CAVENDISH ER BRF 0146 (13)

CONTRACTOR FABRICATED PBU UNITS

PBU SUB REV1 - reviewed.pdf

SHEET1:PBU PLAN
 SHEET2:PBU PLAN UNITS 1&2
 SHEET3:PBU PLAN UNITS 3&4
 SHEET4:PBU TYPICAL DETAILS
 SHEET5:CLOSURE POUR DETAILS
 SHEET6:PBU INSERT-LAYOUT
 SHEET7:PBU-RE-BAR
 SHEET8:QC PROCEDURES/PLAN
 SHEET9:QC PROCEDURES/PLANS
 SHEET10:PBU CASTING PLAN
 SHEET11: CONCRETE MIX DESIGNS
 SHEET12: BRIDGE ANCHORAGE
 (ADDED 2-19-14)

COLD RIVER BRIDGES, LLC 10 LANBRO LANE TEL 603-756-9300 WALPOLE, NH FAX 603-756-9303	
CAVENDISH ER BRF 0146(13)	
COVER SHEET/INDEX	SHEET NUMBER
	COVER
DATE: 2-17-14	Scale:

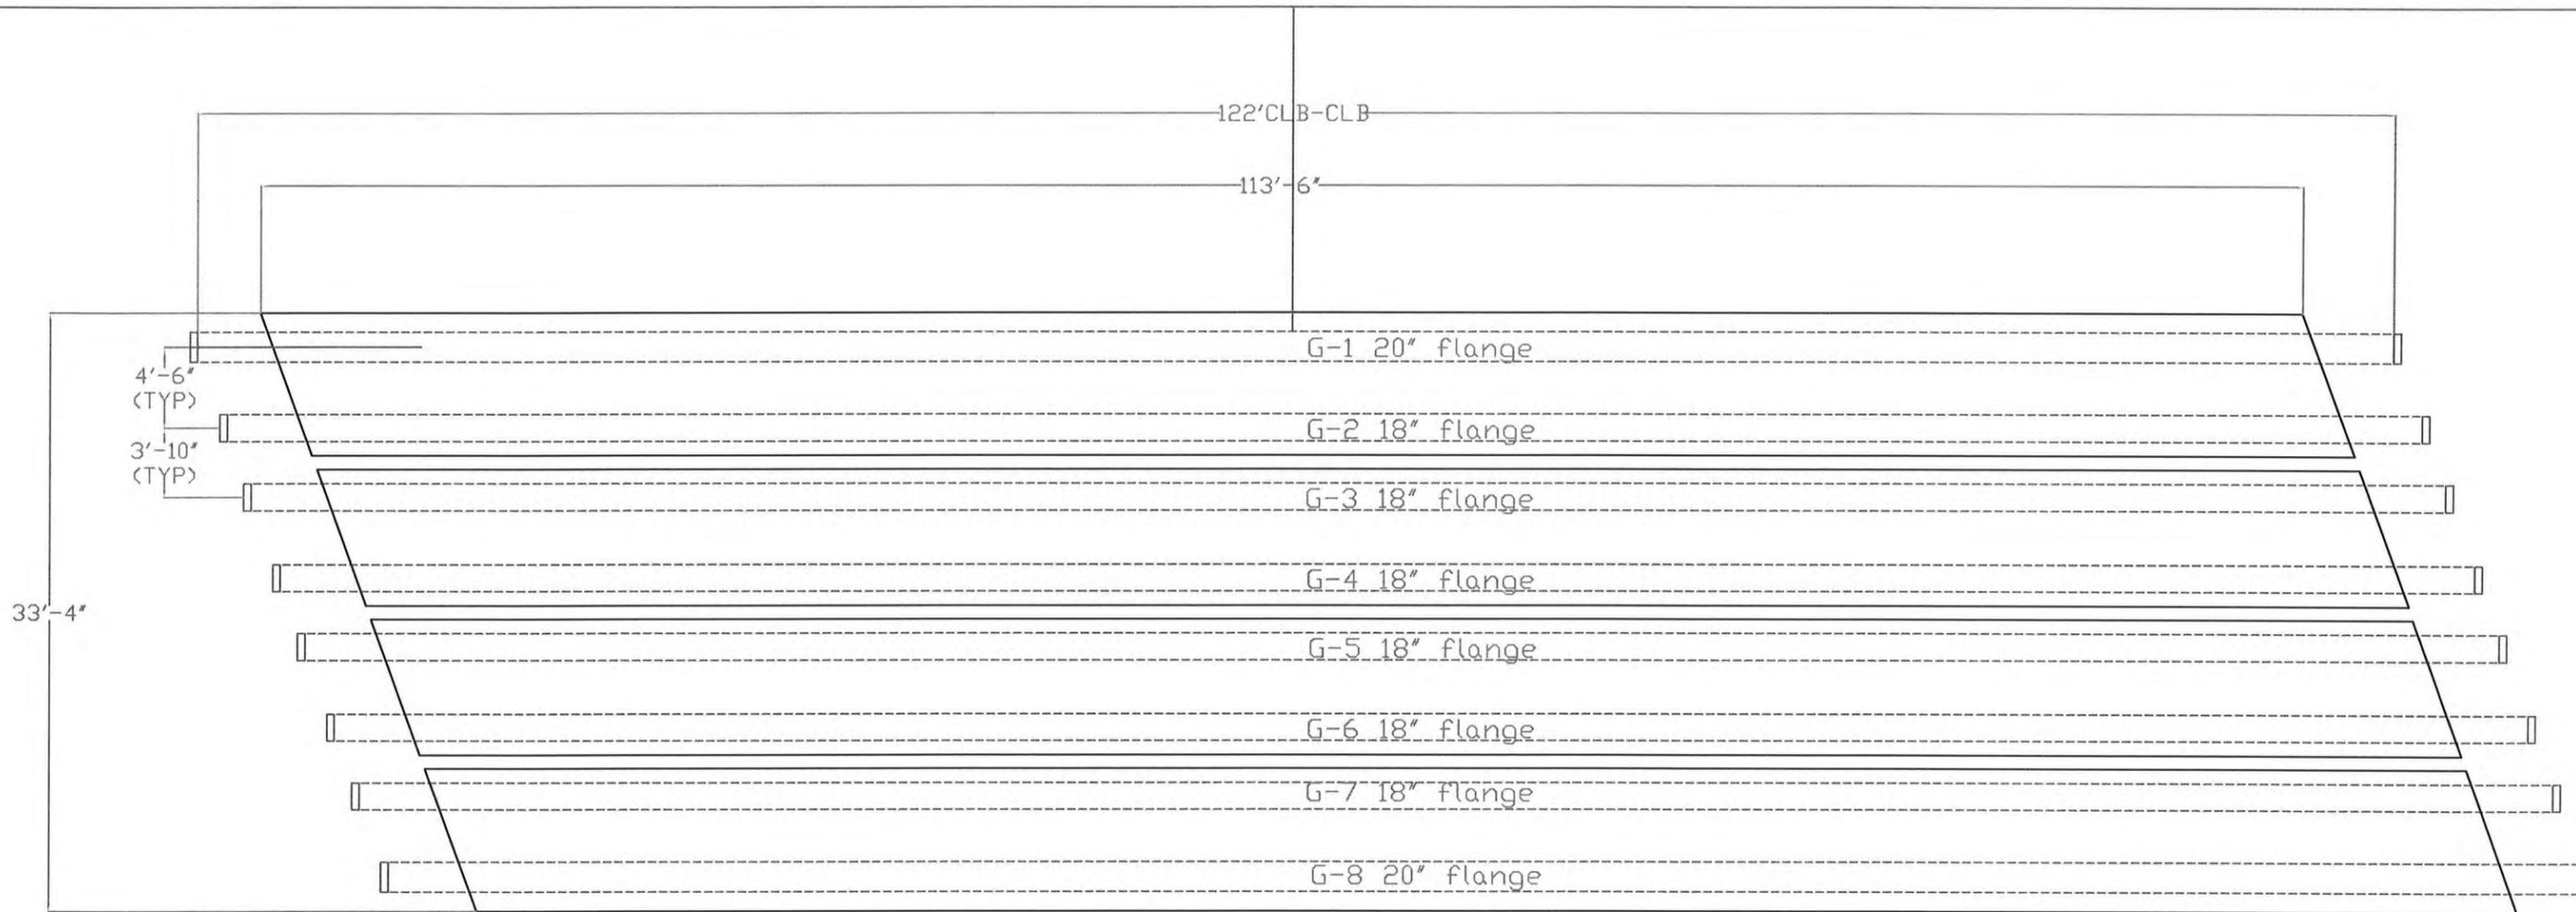
The Steel fabrication drawings should be referenced since they are part of the overall PBU item

It should be understood that the Erection plan needs to be submitted and accepted before the structural steel gets to the site.

COLD RIVER BRIDGES, LLC 10 LANBRO LANE WALPOLE, NH TEL 603-756-9300 FAX 603-756-9303	
CAVENDISH ER BRF 0146(13)	
PBU CLOSURE POUR COIL INSERT LAY-OUT DATE: 1-6-14	SHEET NUMBER <div style="font-size: 2em; text-align: center;">6</div>
scale:

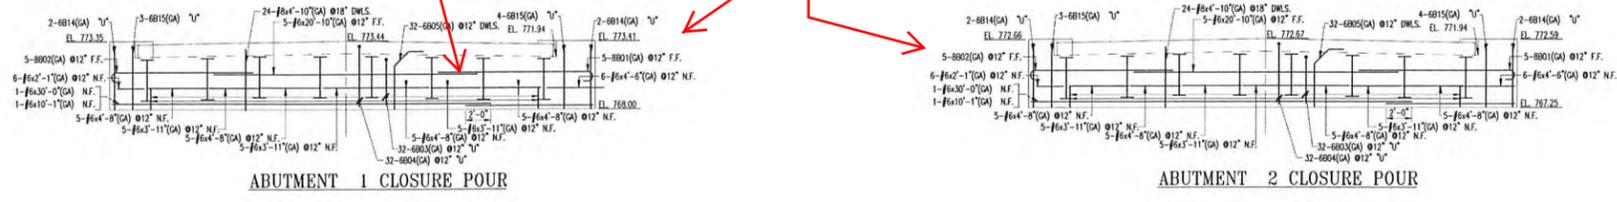
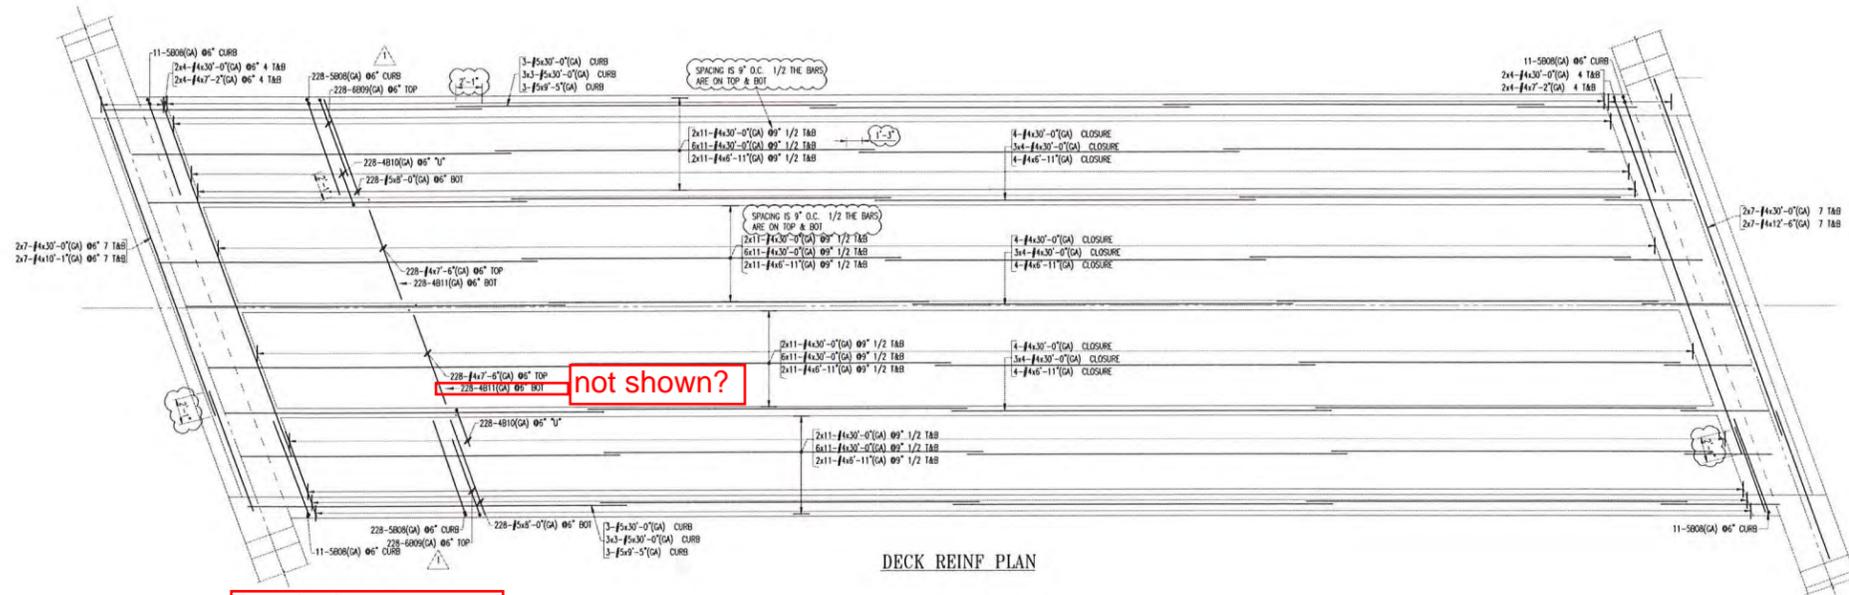
these could be on their own sheet. these aren't precast anyways. they are cast in place closure pour

for normal precast shop drawings, each different element has its own sheet and shows better details

not shown?

PBU-CASTING PLAN	SHEET NUMBER
DATE: 2-17-14	10
Scale:

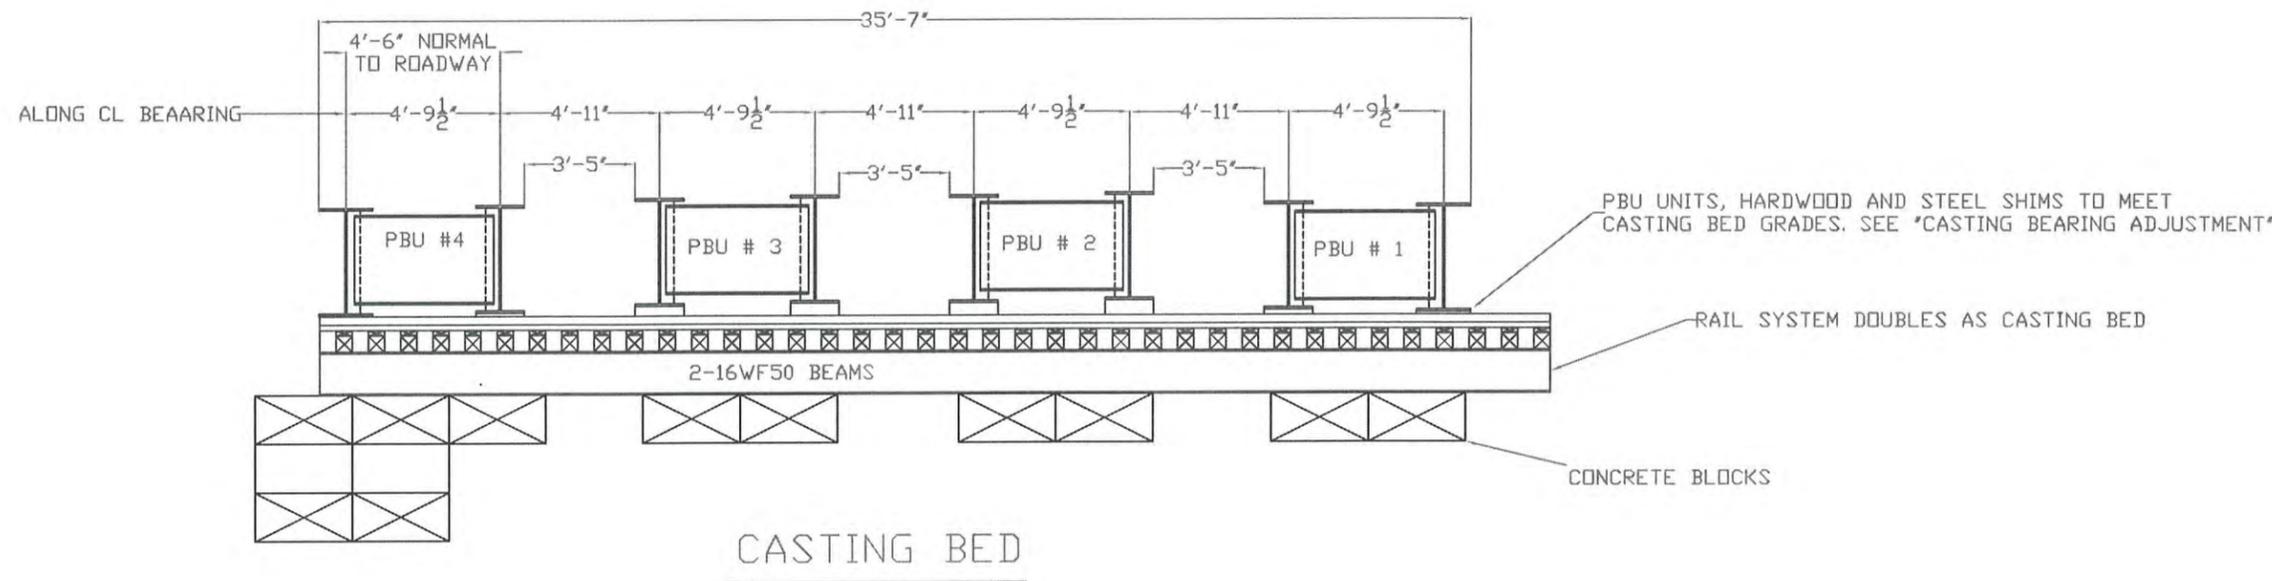
WITH THE GIRDERS SPACED FURTHER APART DURING CONSTRUCTION AS NOTED BELOW, THE BEARING ELEVATIONS NEED TO BE ADJUSTED BEYOND THE DIFFERENCE BETWEEN FINAL ELEVATIONS SHOWN IN THE PLANS (WHICH IS TRUE AS SHOWN FOR PBU'S 2 AND 3 ABOVE)

DIST BETWEEN G1 AND G8 ALONG CL BELOW IS 33.92 FT.

CORRESPONDING DIFFERENCE IN PROFILE IS $33.92 \times \sin(20) = 11.60$ FT

ELEVATION DIFFERENCE BETWEEN G1 AND G8 = $11.60 \text{ FT} \times 0.6149\%$ PROFILE = 0.071 FT.

G7 RELATIVE ELVATION IS 0.08 FT HIGHER THAN G8.

****THEORETICAL BOTTOM OF DECK ELEVATIONS ARE NOT INCLUDED IN THE PLANS,PLEASE PROVIDE.PLEASE PROVIDE ELEVATIONS BASED ON FINAL LOCATION.
